**1970 - 1973 Corvette: Service Bulletin:
Overheating - 454 Cu.In. Engine with Air
Conditioning**

73-T-28

Subject: ENGINE OVERHEAT - 1970-1973
 CORVETTES WITH 454 CU. IN.
 ENGINES AND AIR CONDITIONING

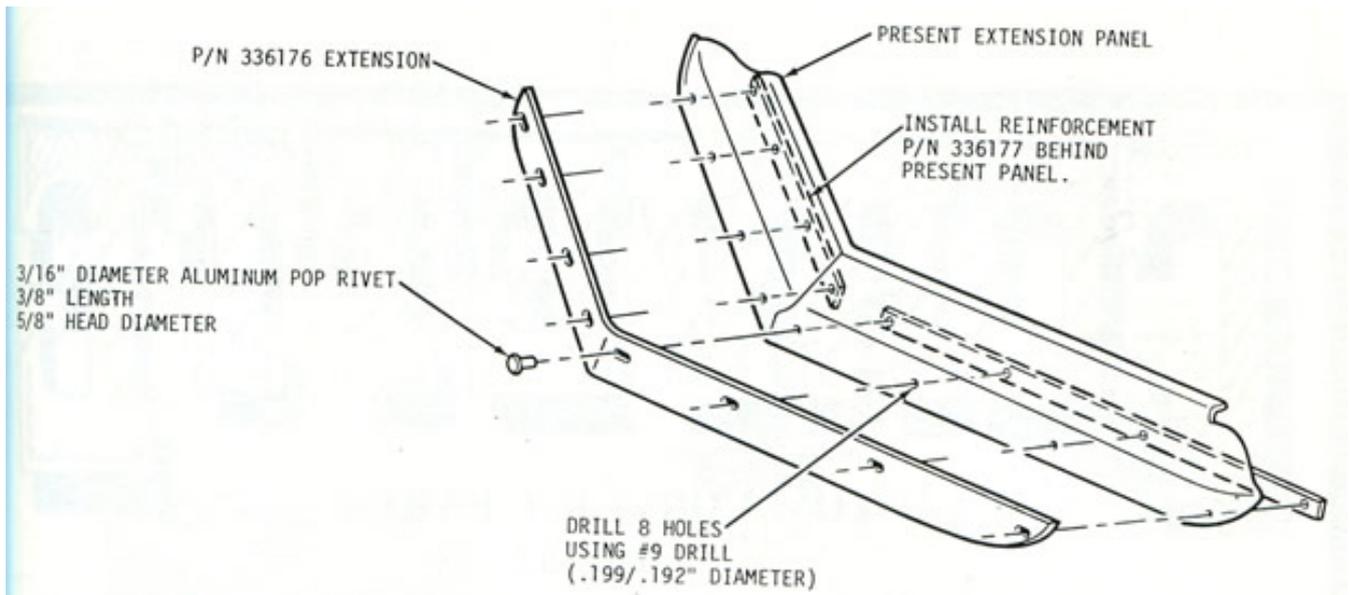
Engine overheat may be encountered on some 1970-1973 Corvettes equipped with the 454 cu. in. engine and air conditioning during high ambient temperatures when operated in heavy traffic. This condition is due to the limited amount of air flowing through the radiator at low vehicle speeds or during periods of extended idle.

To improve low speed cooling, an additional grille panel lower extension was installed in 1973 Corvettes produced after Vehicle Identification Number 1Z37Z3S410722. This extension, Part Number 336176, may be installed as illustrated on page 2 of this bulletin on early 1973 Corvettes only.

In addition, a flex fan that provides increased air flow through the radiator has been released for service use on any 1970-1973 Corvette with 454 cu. in. engine and air conditioning. This fan replaces the original fan and fan clutch assembly and may be ordered in a kit, Part Number 6260480, that includes the necessary attaching parts. When using the flex fan, an increase in fan noise may be noticed under some driving conditions.
